**KANSAS CITY  
MISSOURI**

# Ordinance 240335

TI & O Committee

# Standards Change Process

# Speed Humps (1 of 2) – TC-SH-1

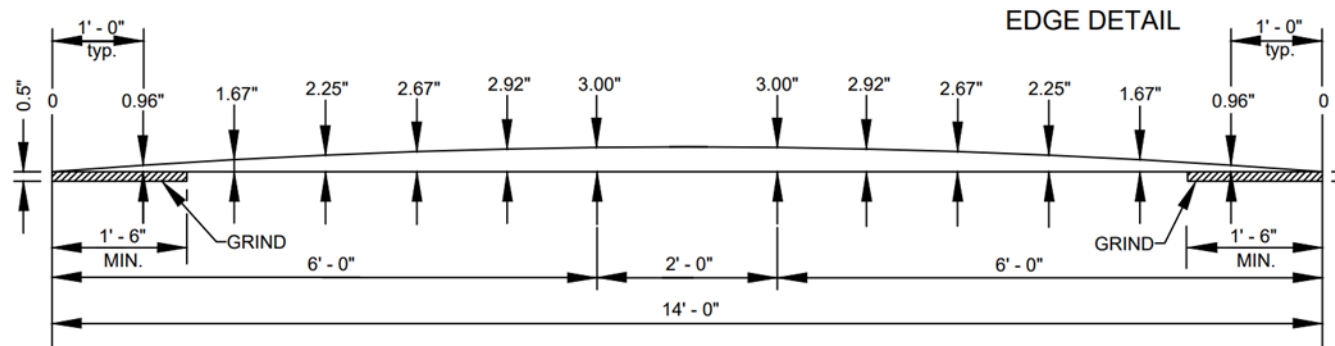
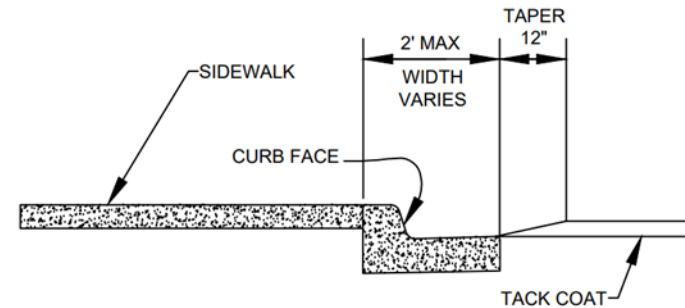
- Updated intersection spacing from 150ft to 125ft
- Added signage details for standard drawings
- Updated use of Type 5 asphalt instead of Type 3
- Added waiver requirements for curbs

# Raised Crosswalk (1 of 7) – TC- RC-1

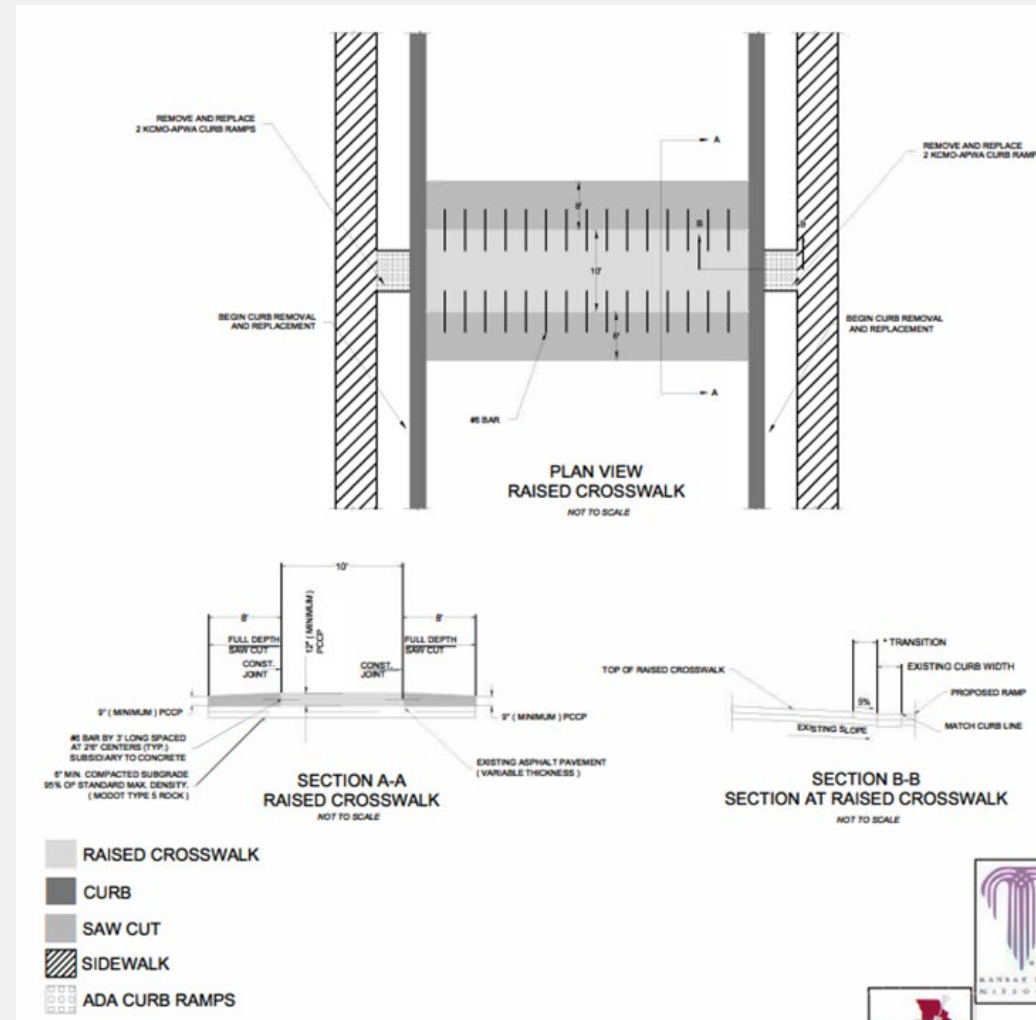
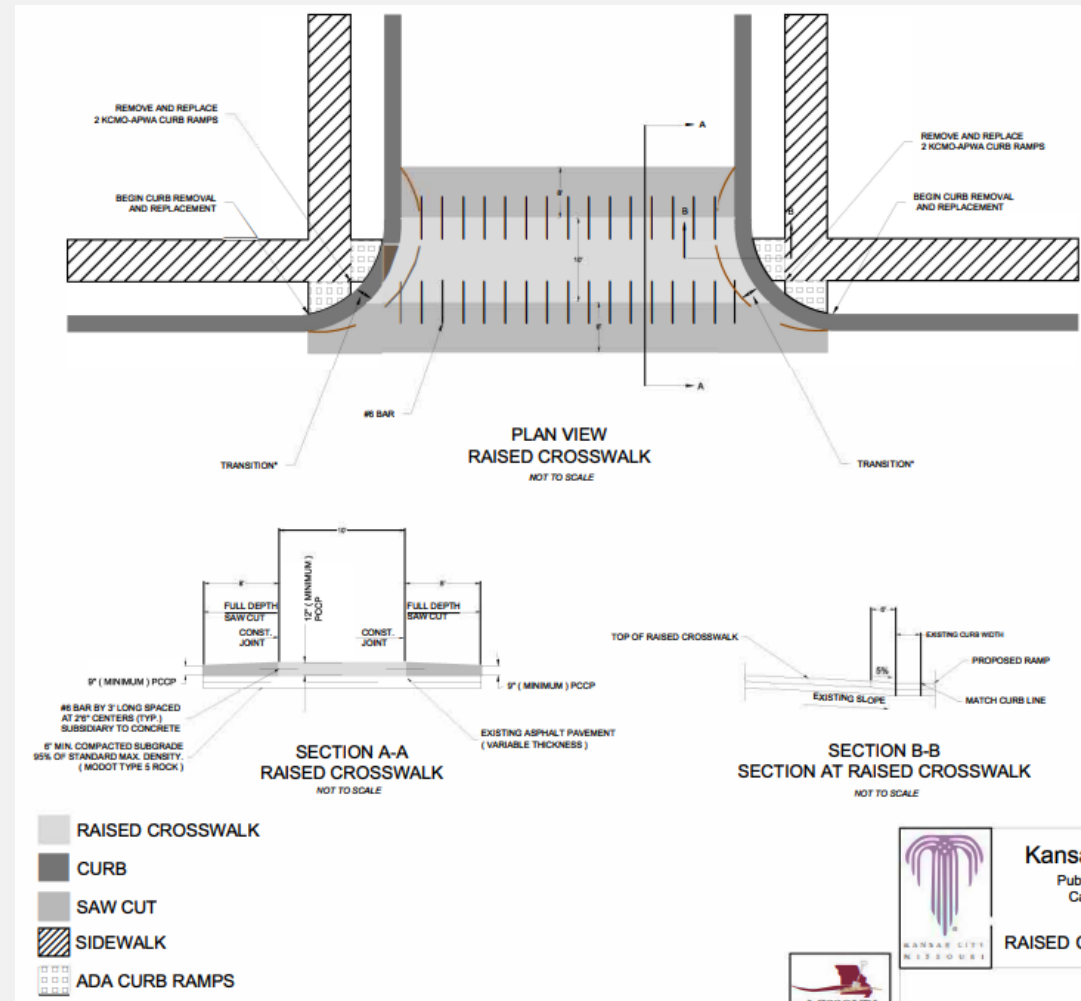
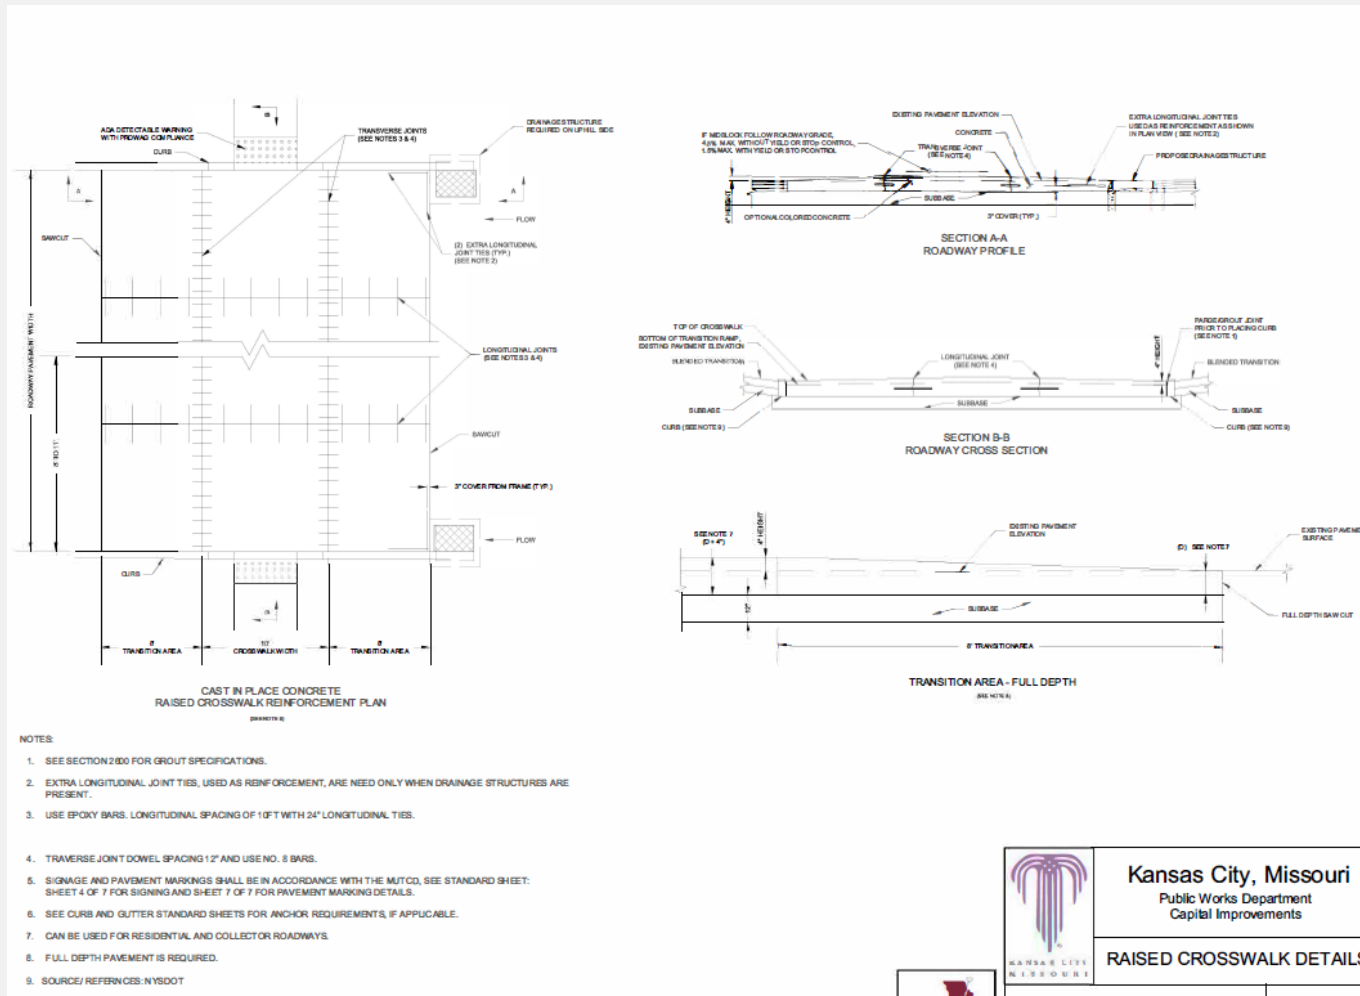
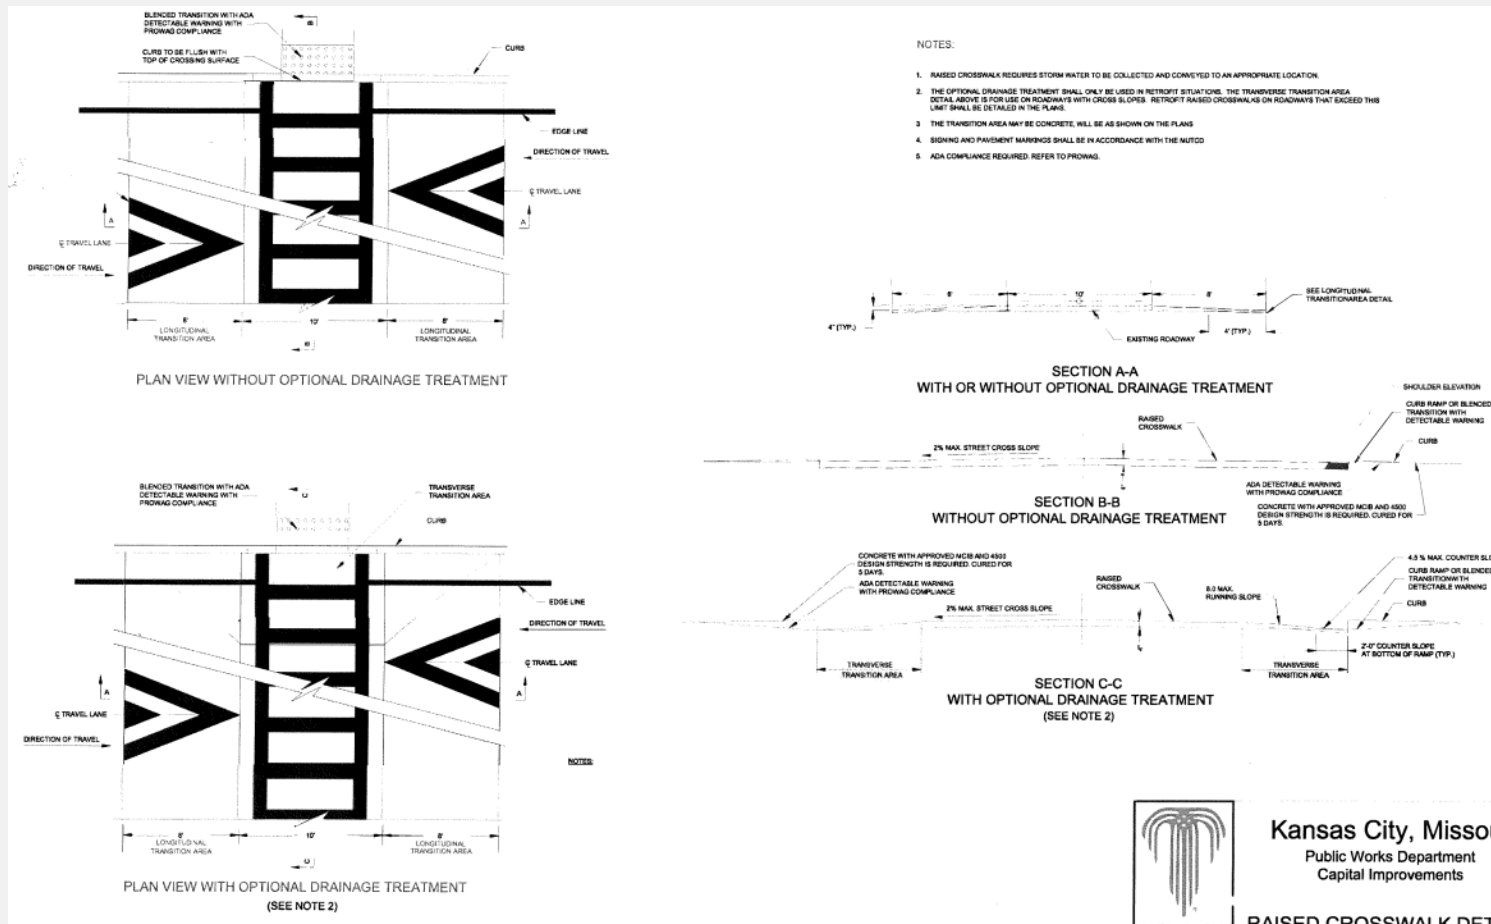
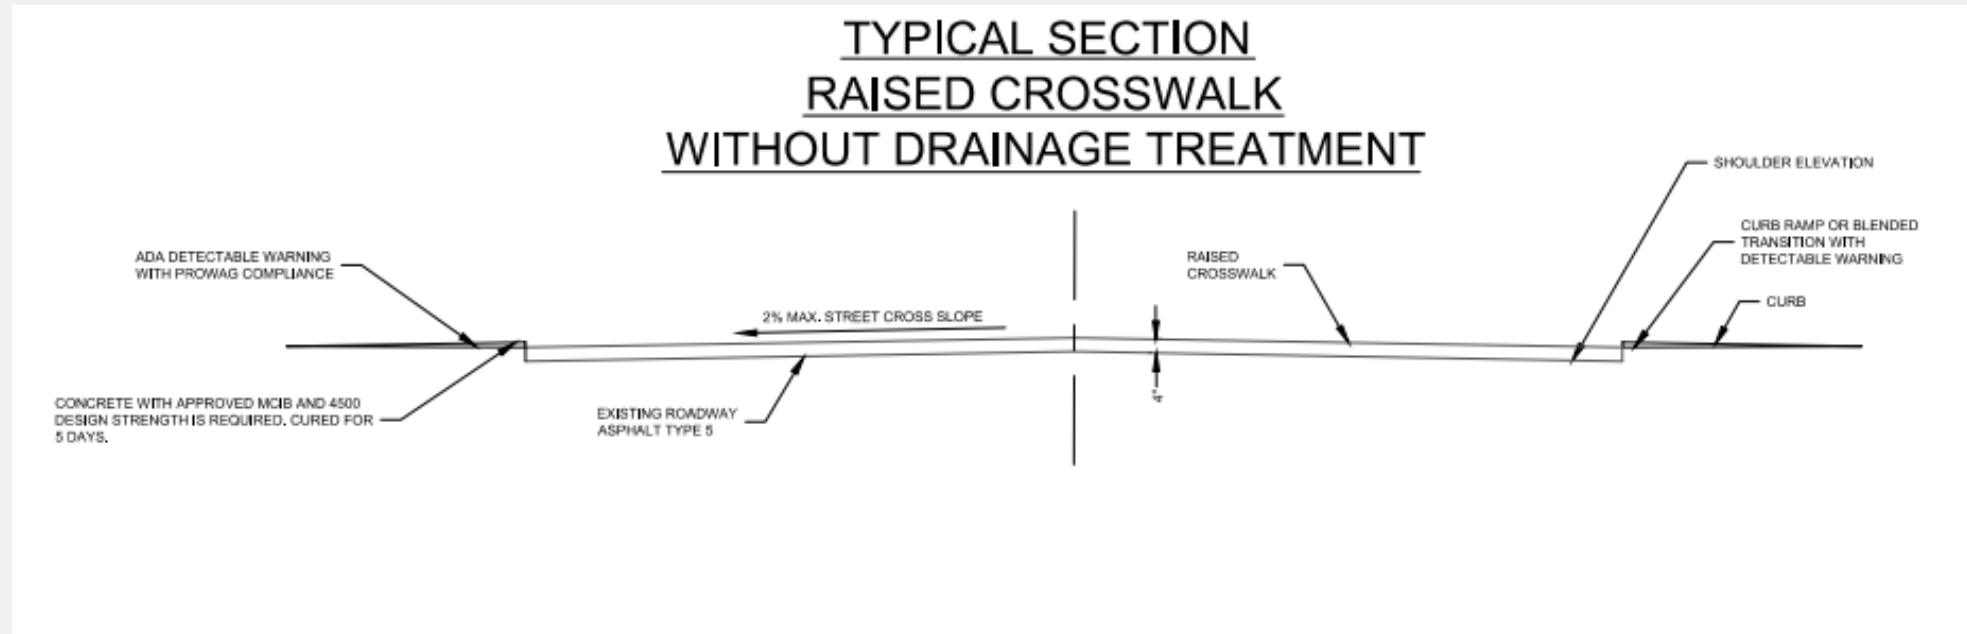
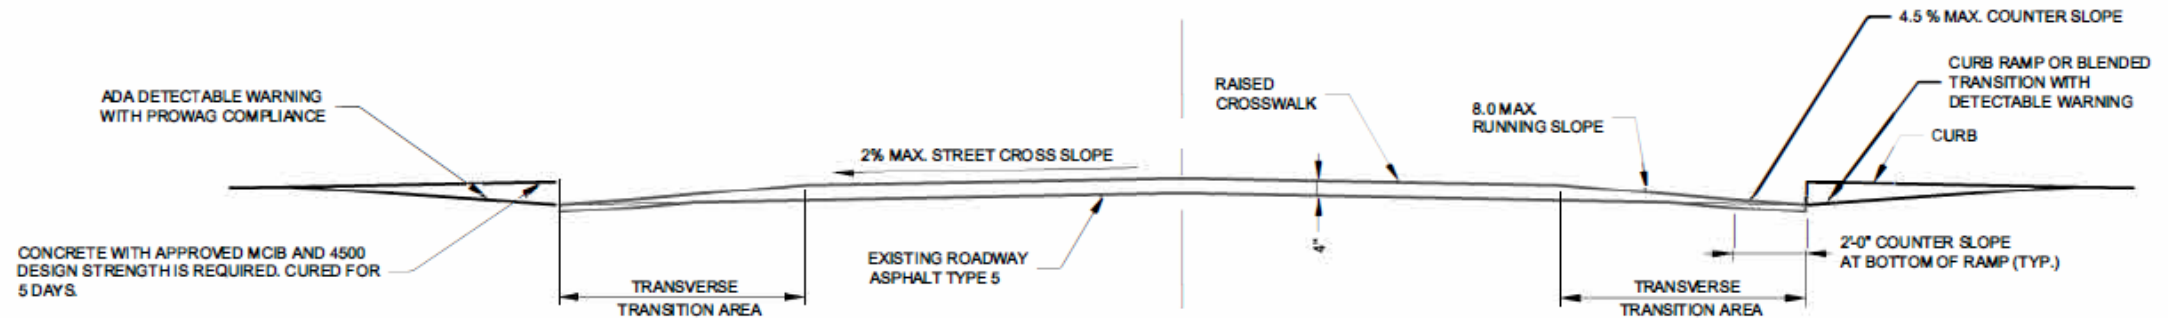
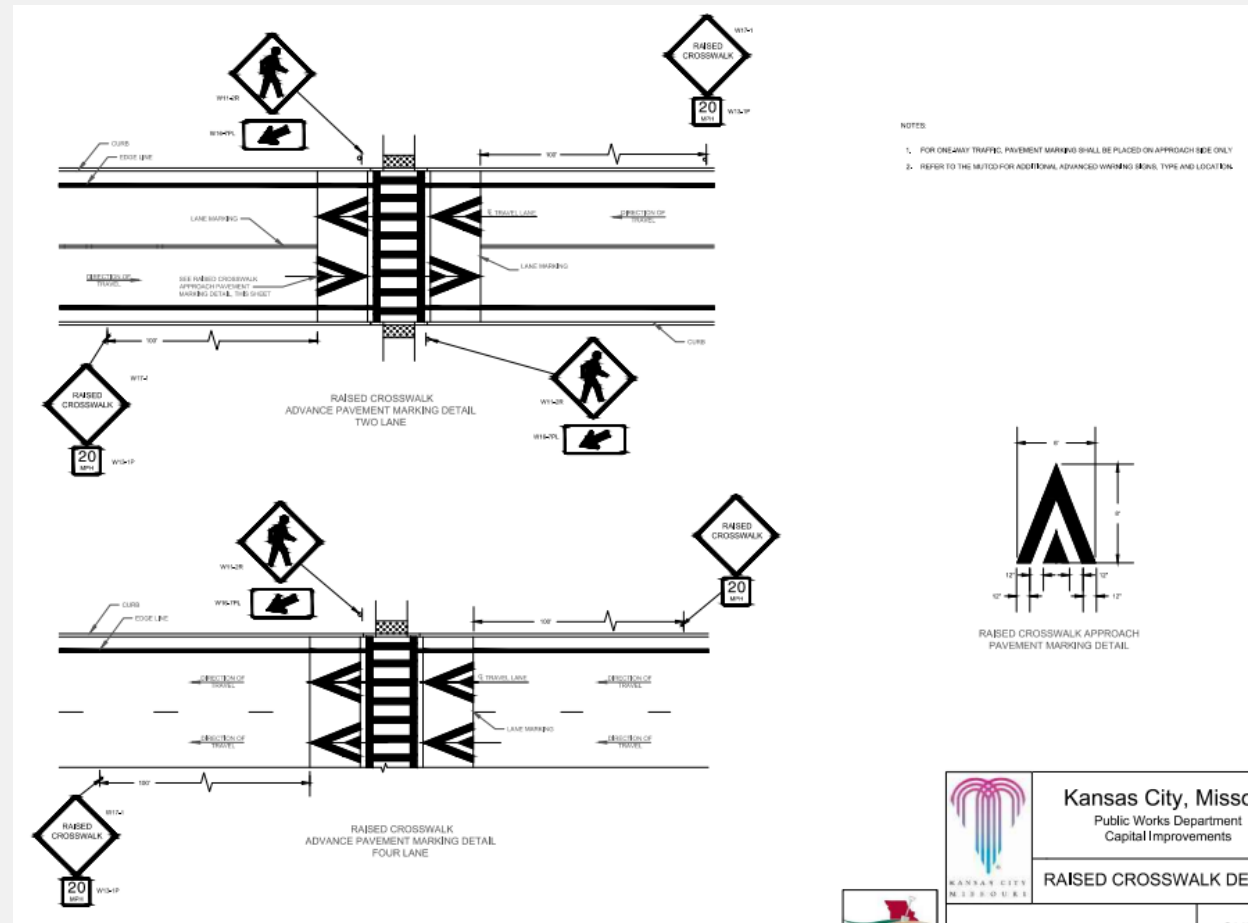
Added new standard with various scenarios for drainage treatment

# Raised Intersection – TC-RI-1

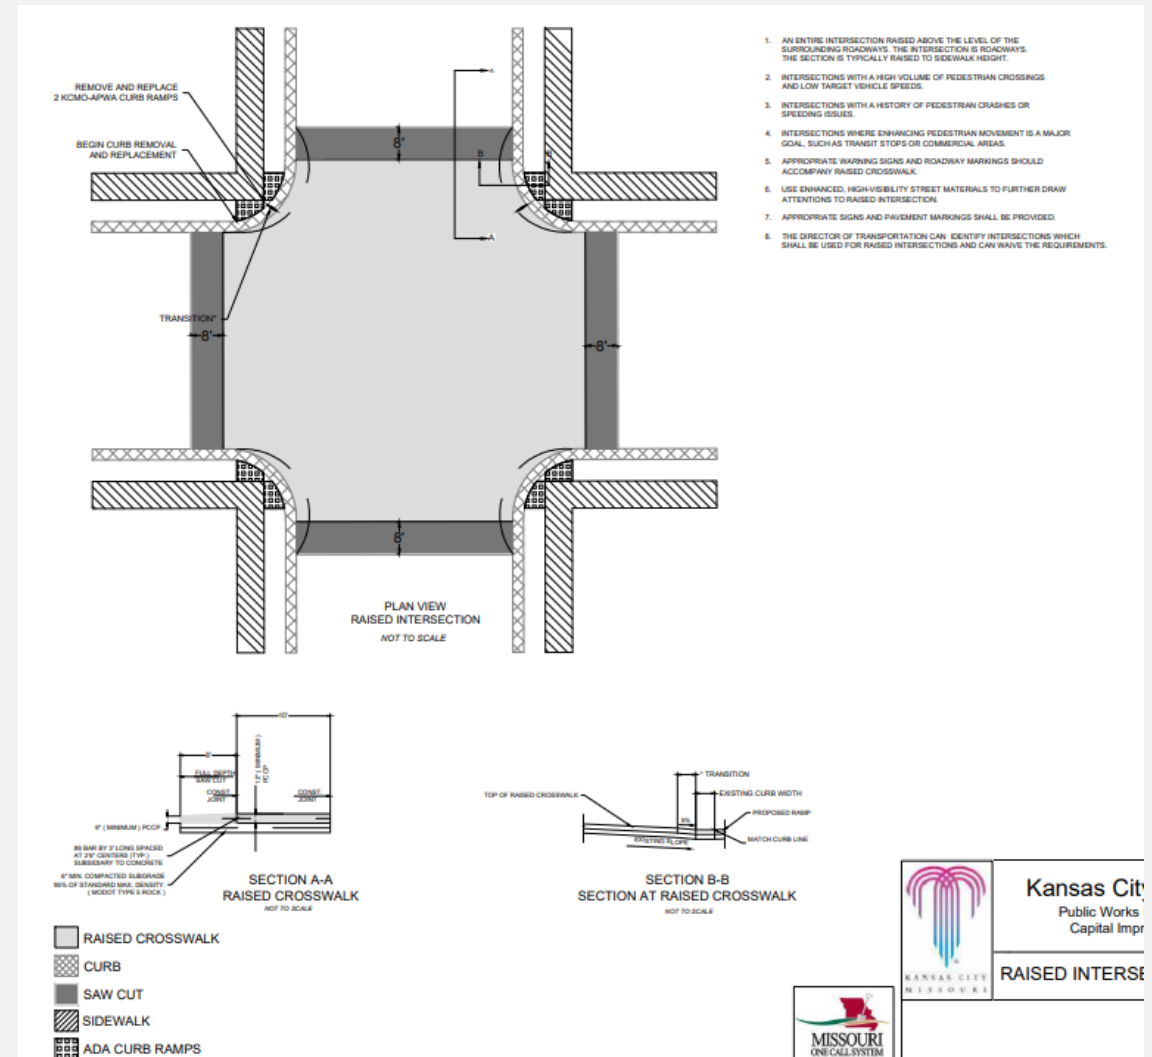
Added new standard

# Chicane (1 of 2)- TC-C-1

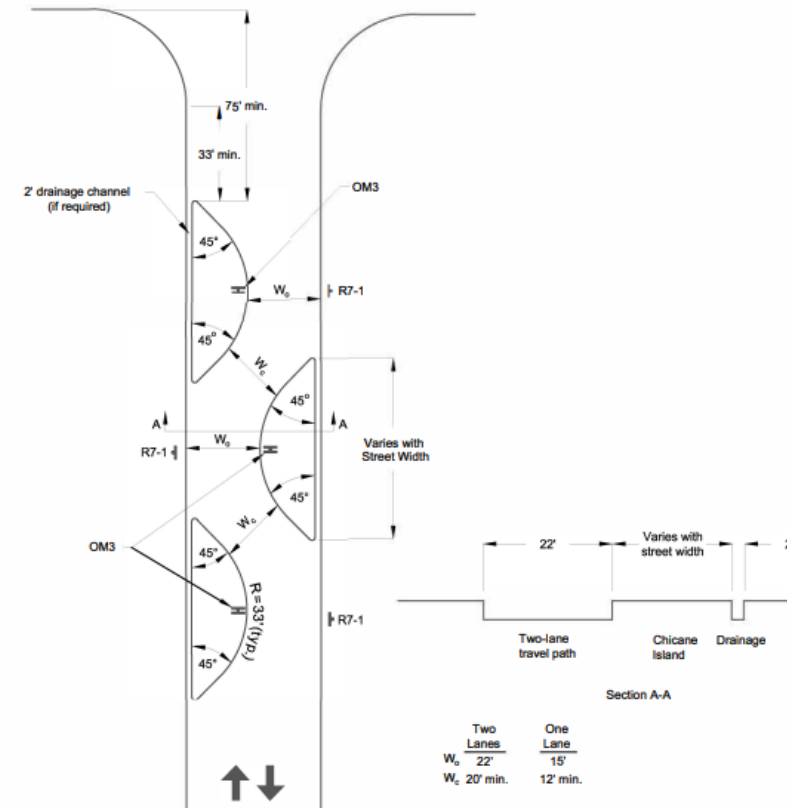
Added new standard
